STAFF RECOMMENDATION

1615 Forrest Avenue

January 20, 2021

Application: New Construction—Addition

Figure 2 (left) shows the addition and Figure 3 (right) is the 1957 Sanborn map which does not show the addition's footprint

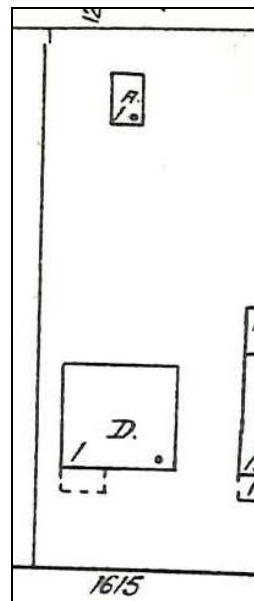
Demolition: The project includes removing an existing addition (Figure 2). The addition's date of construction is not known, but it does not appear on the 1957 Sanborn map (Figure 3). Staff finds that the addition's date of construction and its location at the rear, where it is not highly visible from the street do not contribute to the historic character of the house.

Figure 4. The alteration to the window opening is indicated with the box.

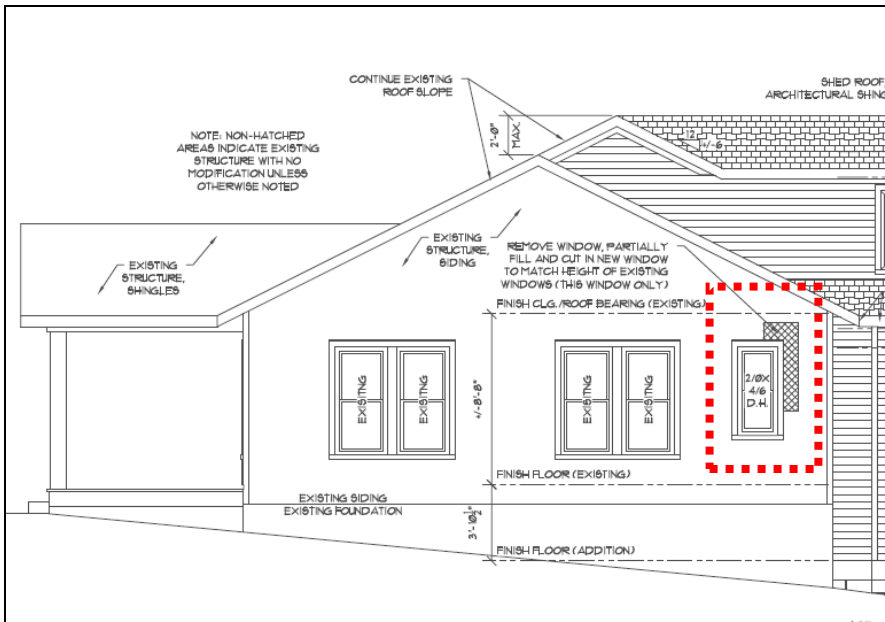
The applicant also proposes a change to the windows openings on the right façade, towards the back of the house (Figure 4). Staff finds that because this window opening is in the back half of the house and because the opening will only be shifted slightly, that the alteration is appropriate demolition under the design guidelines.

Staff finds that the removal of the existing addition and the window alteration on the right façade to meet Section III.B.2. of the design guidelines for appropriate demolition.

SITE PLAN AND
DEMOLITION PLAN

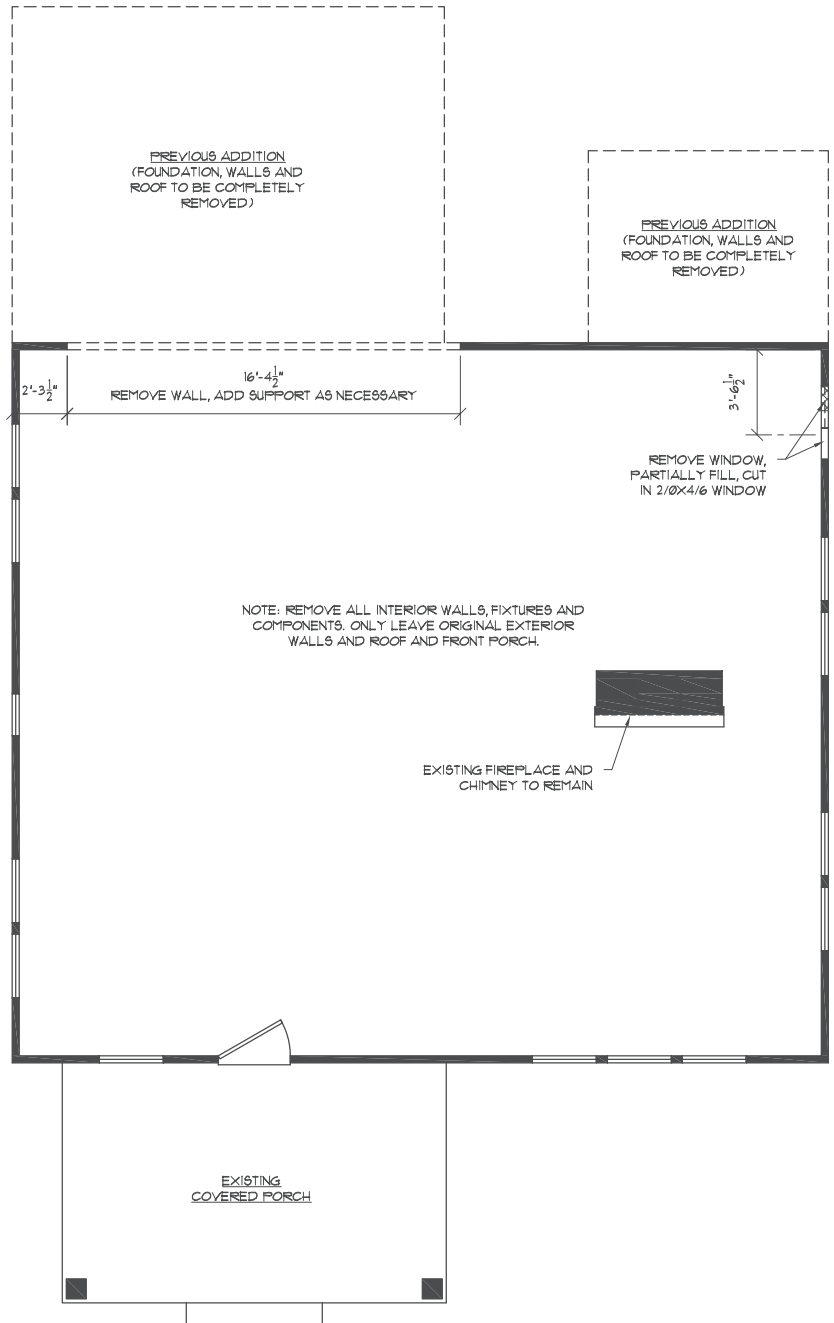
Setback & Rhythm of Spacing: The addition meets all base zoning setbacks. It will be approximately six feet (6’) from the right-side property line, seven feet (7’) from the left side property line, and forty-nine feet (49’) from the rear property line. The addition will not affect the historic house’s rhythm of spacing along Forrest Avenue.
